Re: Lila Canyon Mine, UtahAmerican Energy, Inc. C/007/013
Culvert UC-1 Task ID #5304

APPLICATION FOR PERMIT PROCESSING

**Appendix 7-4
Lila Canyon Mine
Sedimentation and Drainage Control Plan**

DRAWN BY	PJ	SCALE	1" = 40'
APPROVED BY	DH	DATE	18 OCT. 2016
SHEET	PLATE #1 of 1

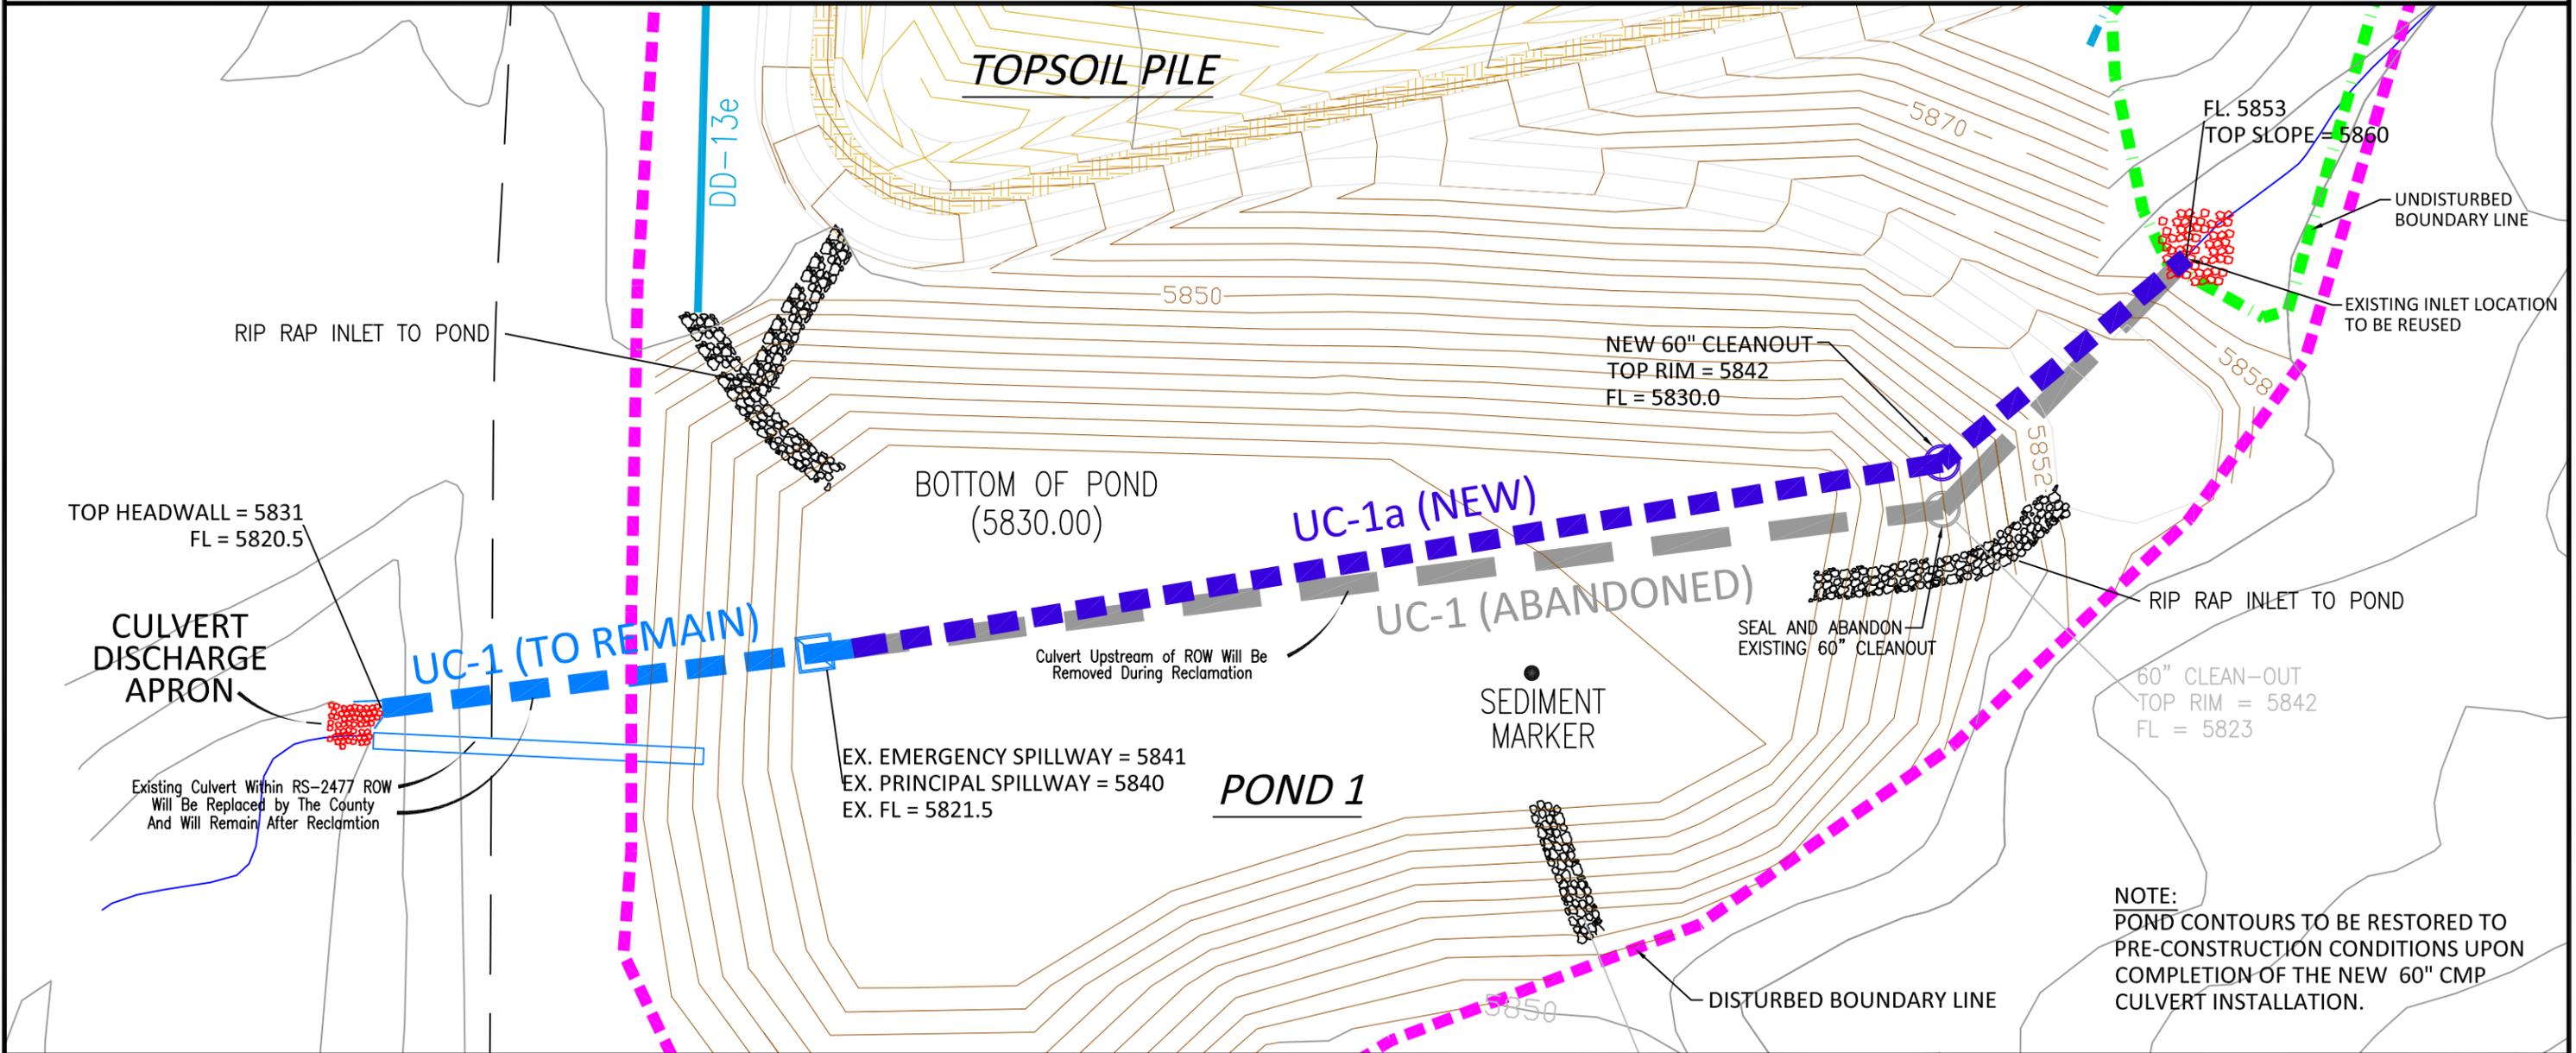
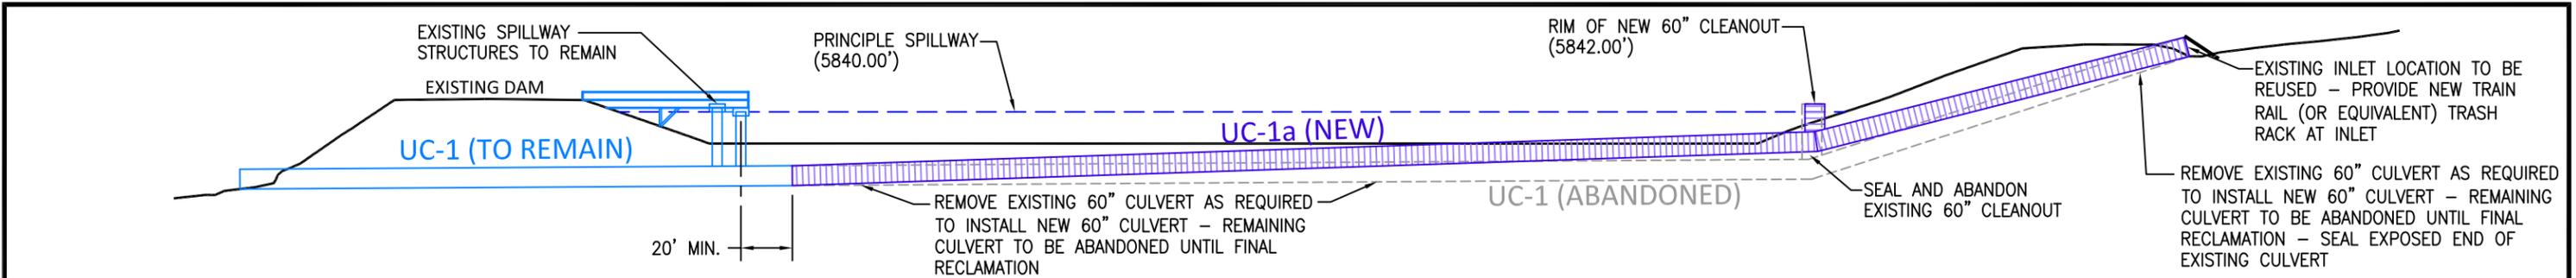
UtahAmerican Energy, Inc. thus proposes to install a new 60" diameter culvert, beginning at the existing inlet location and extending below Pond 1, then attaching to the existing 60" diameter culvert near the existing spillway structures. The existing plugged culvert would be cut and removed as necessary for the installation of the new culvert, then sealed and abandoned. The abandoned portion of the existing culvert would remain in-place until final reclamation. Upon final reclamation, the abandoned and new culvert sections will be removed in accordance with the approved reclamation plan.

Attached to this letter is a plan showing the proposed location of the new 60" CMP culvert sections, and a pond profile showing the new sections of culvert in relation to the existing culvert. The proposed location of the new culvert is shown on the map. A certified as-built drawing will be submitted upon completion of the new culvert sections.
